CITY OF PORTLAND, MAINE
DEPARTMENT OF BUILDING INSPECTION

LOCATION 653 Congress St OWNER Reveries Inc

Mr. Ernest L. Foss,
653 Congress Street,
Portland, Maine

Enclosed is the building permit covering alterations in the drug store at 653 Congress Street to partition off a new kitchen. Please note the following:

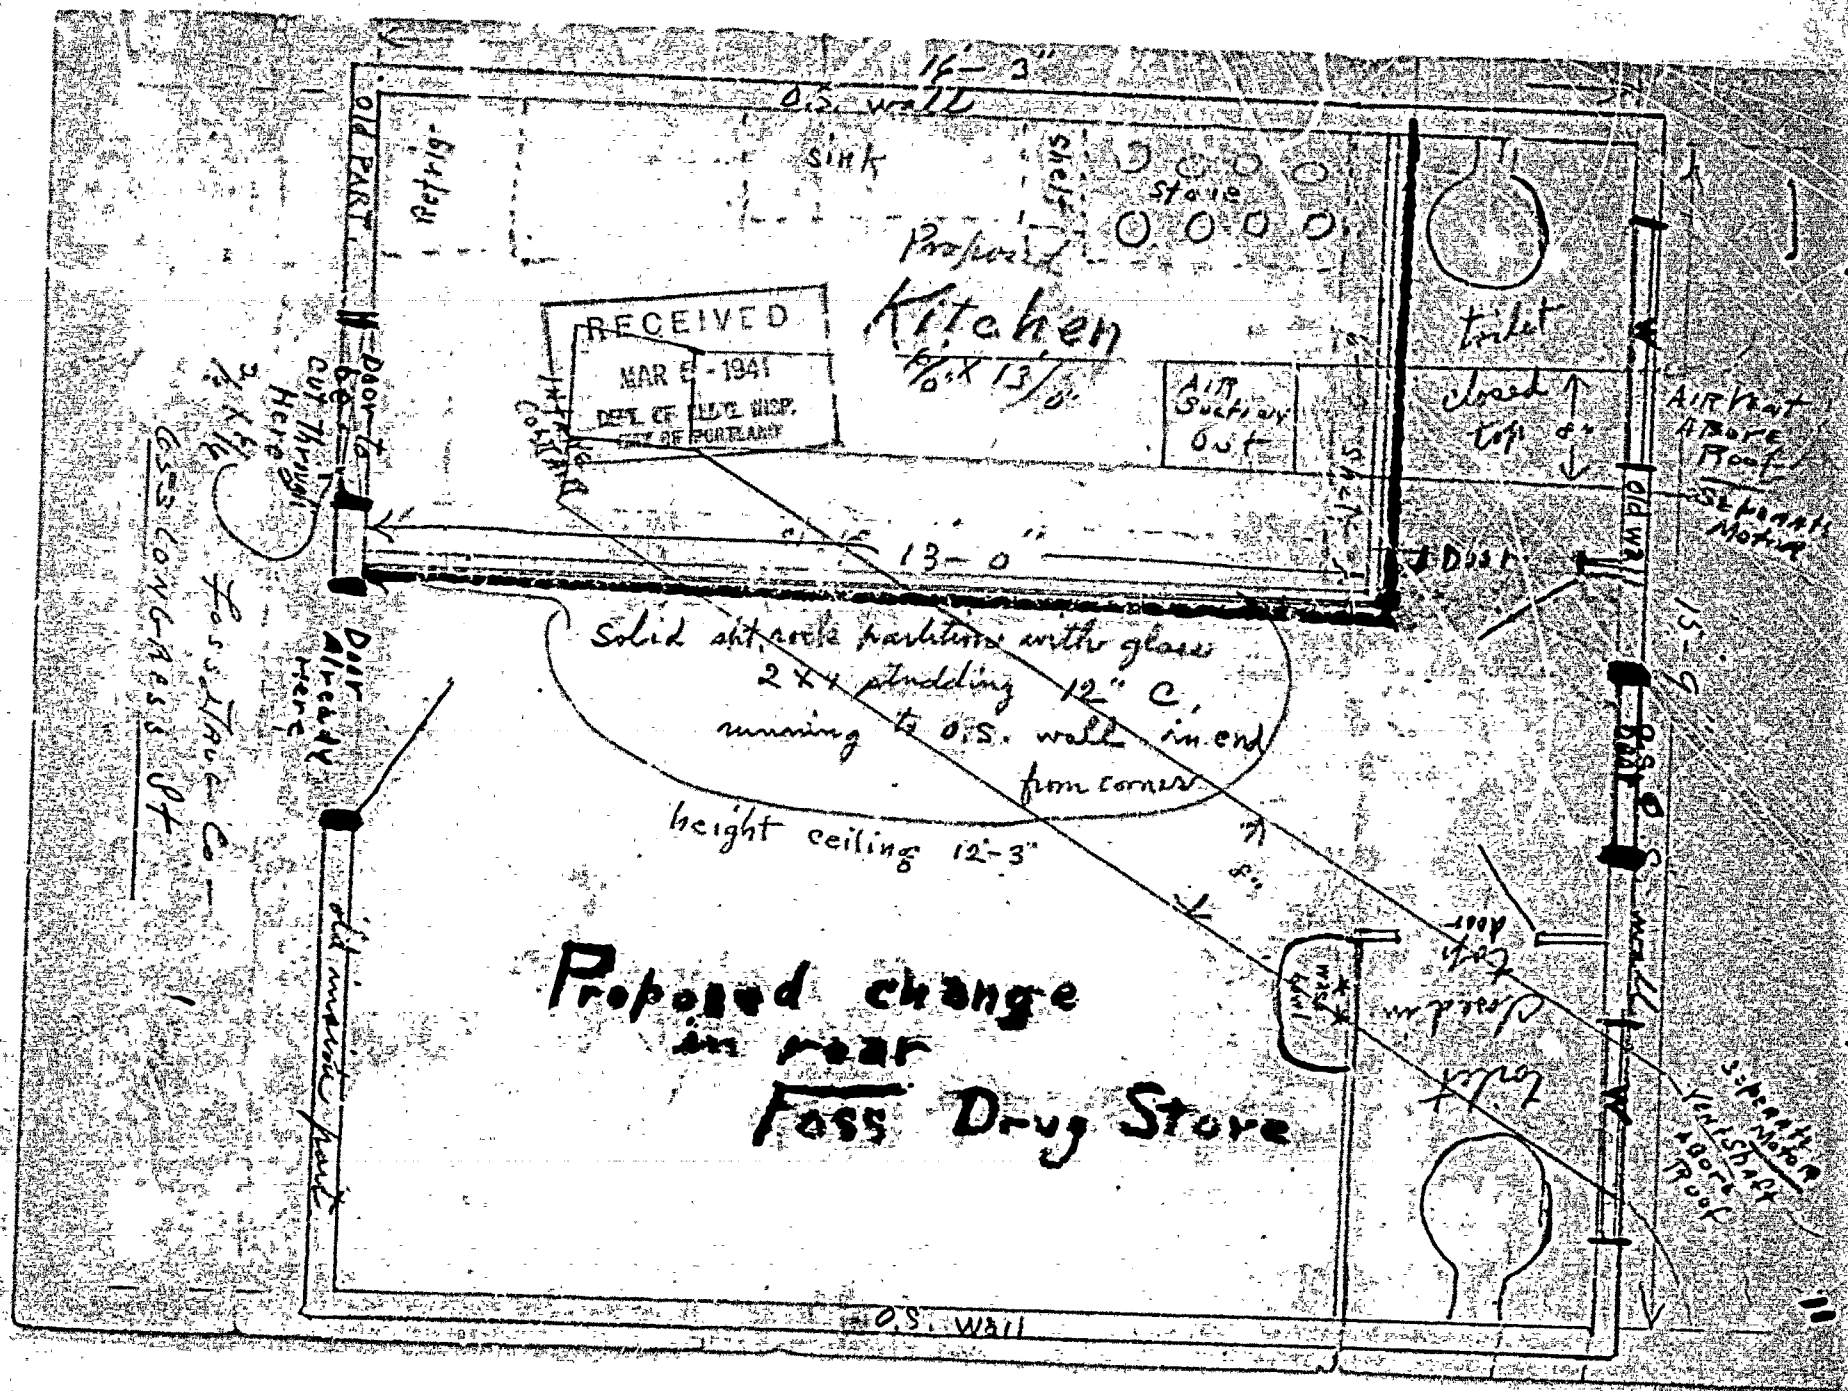
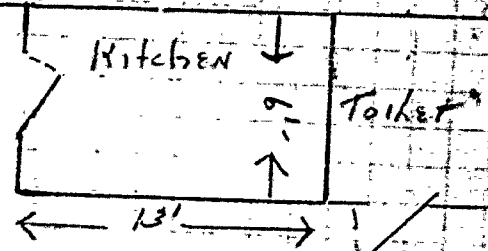
Because food is evidently going to be prepared and served on the premises and because the Building Code provides that no toilet room shall open directly into any room where food is prepared or served, it is necessary that you supply a suitable self-closing device on each toilet room door and on the door leading from the rear room and the drug store, this rear room being the one through it is necessary to pass in order to reach the toilet rooms. By the term "self-closing" is meant a door which is normally closed and kept closed by a suitable device such as a door check or a suitable spring. Each of these three doors must fit its opening tightly.

Because this kitchen is to be a room without any outside windows in it, I understand that the Health Department is requiring that some type of mechanical ventilation be provided for the room, that the hood over the cooking appliance be vented suitably to the outside air. A sketch which has been supplied with the application for the permit seems to show an intake fan intended to take cold air from the outside, push it through a metal duct into the kitchen, and another exhaust fan designed to draw air from the kitchen through a metal duct and discharge it outside the building. I claim no particular knowledge of ventilation design, but from what knowledge I have I doubt if this arrangement will work satisfactorily. To the contrary, I believe the diverse currents of air introduced will not only fail to ventilate the kitchen, but may seriously interfere with the operation of any fire-actuated device in the kitchen. I am sure this department and I doubt if the Health Department either will take any responsibility for the satisfactory operation of this arrangement. If it is put in operation and does not work satisfactorily, especially if it seems to interfere or make hazardous the use of the appliances in the kitchen or elsewhere, it will be necessary to change it when such conditions are found out. If you contemplate now cooking or hot water heating devices in the kitchen, when permits for those appliances are applied for we shall have to go into the matter of their safe operation under those circumstances with the installer very carefully.

Under the circumstances the best advice I can give is either that you extend the kitchen to the rear, relocating one toilet room and then provide an outside window in the kitchen and eliminate the complex ventilating system, or else employ a ventilation engineer of un doubted ability to design a ventilation system that will work under all circumstances, taking into account all factors.
